**From:** David Weber <dweber@wearehls.com>  
**Sent:** Thursday, June 11, 2020 1:58 PM  
**To:** Wooldridge, John; Chris E. Howard; Norton, Harvey; James Howard  
**Cc:** Heim, Kimber  
**Subject:** RE: 110412 FAI 037 Safety Project Authorization (NTP) for Appraisals

**Subject:** RE: FAI-37-6.34 Preliminary Right of Way Plans (PID No. 110412)

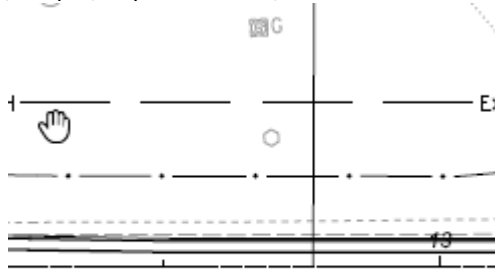
- Missing sheet 20 of 37 as Luke stated.
- Page 21/36 (22/37) Parcel 11-SH shows "Utility Pole Save" for private light poles. I would have them removed as ODOT will need to pay for them anyways (in take area) and would need to do a permit (not recommended) for the poles that are very close to the fence needing removed. Same Parcel has three of those poles (not 2) and also has a small sign near the fence that was not picked up on these plans:
